City of Portland, Maine - Building or Use Permit Application 389 Congress Street, 04101, Tel: (207) 874-8703, FAX: 874-8716

Proposed Project Description: Construct Addition (1,866) Sq Ft as per plans		Signature: _____ Date: _____		Signature: _____ Date: _____		Historic Preservation: <input checked="" type="checkbox"/> Not in District or Landmark <input type="checkbox"/> Does Not Require Review <input type="checkbox"/> Requires Review	
Permit Taken By: Mary Gresik		Date Applied For: 16 October 1996		Signature: _____ Date: _____		Action: <input type="checkbox"/> Approved <input type="checkbox"/> Approved with Conditions <input type="checkbox"/> Denied

Re: 1364 Washington Avenue

Your application to construct an addition (32'x 54') has been reviewed and a permit is herewith issued subject to the following requirements: This permit does not excuse the applicant from meeting applicable State and Federal laws.

Job	Truss	Truss Type	Qty	Ply
GAMBRELS	34ROOF	FLAT TRUSS	17	1

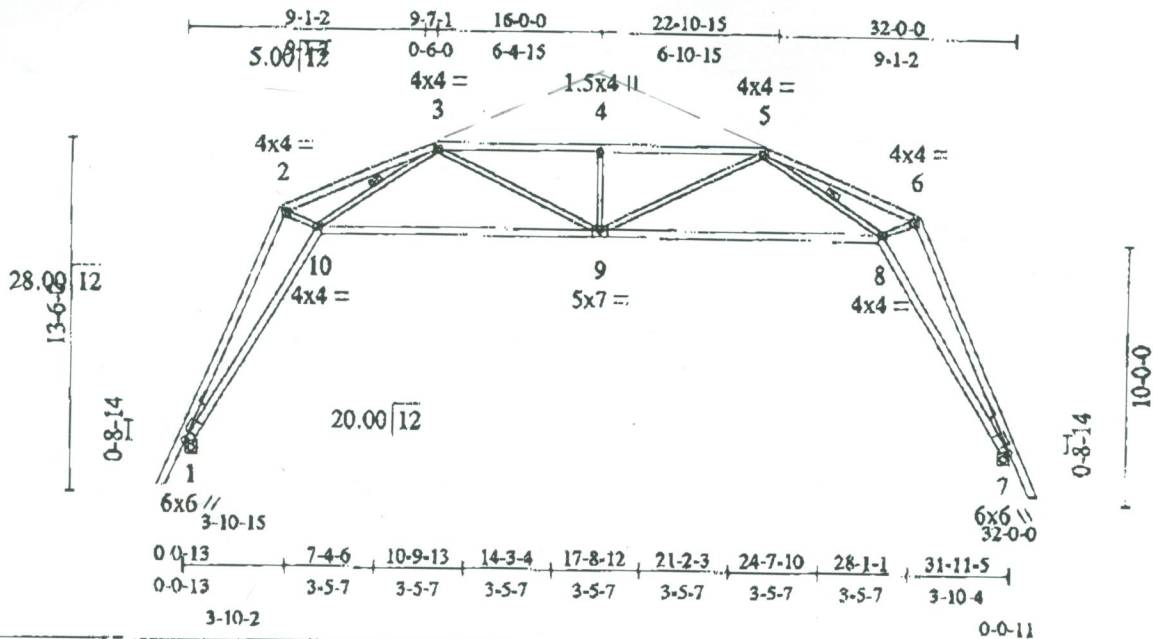
NOTES
 1) Non Standard bearing condition. Review required.
 2) Provide adequate drainage to prevent water ponding.
 3) As requested, plates have not been designed to provide for placement tolerances or rough handling and erection conditions. It is the responsibility of the fabricator to increase plate sizes to account for these factors.

Job	Truss	Truss Type	Qty	Ply
GAMBRELS	34FLOOR	FLAT TRUSS	17	1

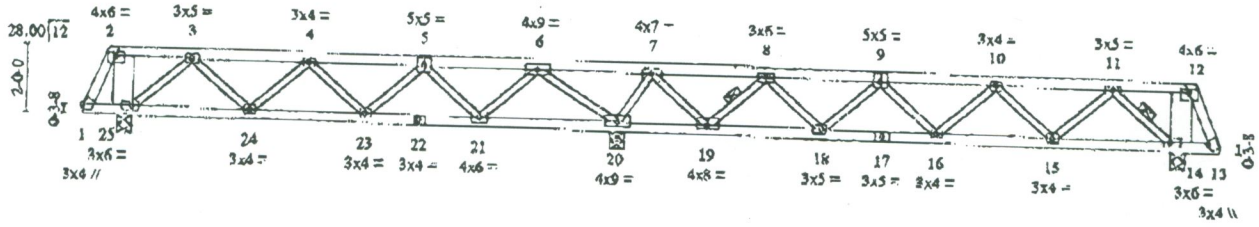
NOTES
 1) This truss has been checked for unbalanced loading conditions about joint 9.
 2) As requested, plates have not been designed to provide for placement tolerances or rough handling and erection conditions. It is the responsibility of the fabricator to increase plate sizes to account for these factors.
 3) Required bearing size at joint(s) 20 greater than input bearing size.

Job	Truss	Truss Type	Qty	Ply
GAMBRELS	34ROOF	FLAT TRUSS	17	1

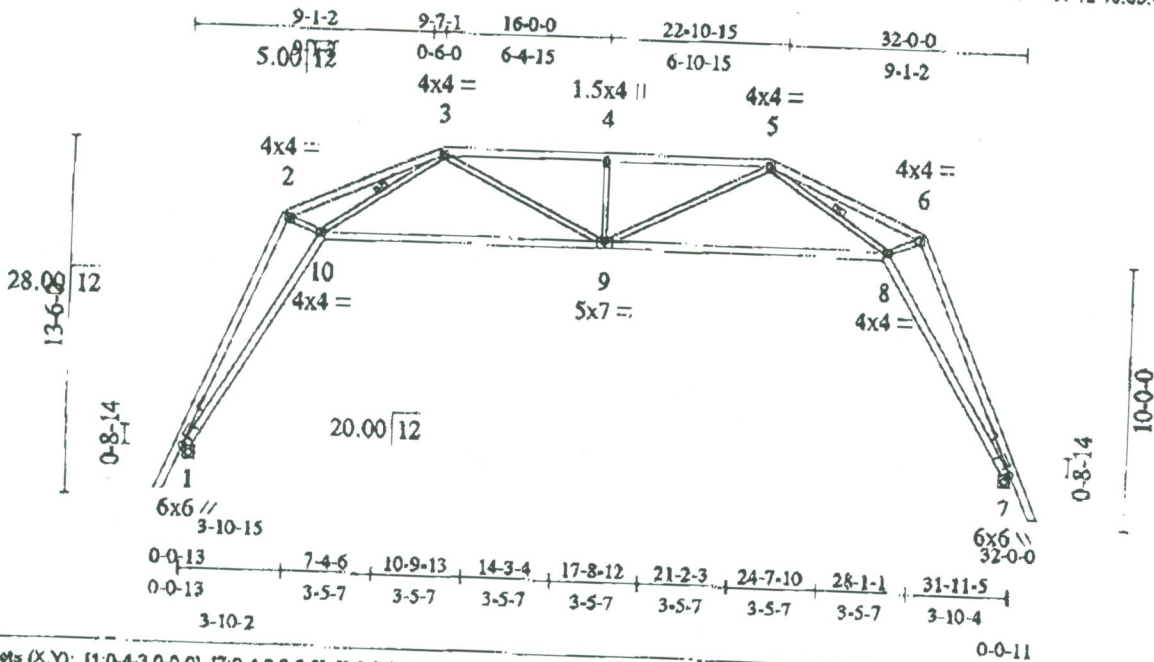
Change roof style from gambrel to trusses as per plans
 Elevation of building to be 1' higher with new roof style.

NOTES
 1) Non Standard bearing condition. Review required.
 2) Provide adequate drainage to prevent water ponding.
 3) As requested, plates have not been designed to provide for placement tolerances or rough handling and erection conditions. It is the responsibility of the fabricator to increase plate sizes to account for these factors.
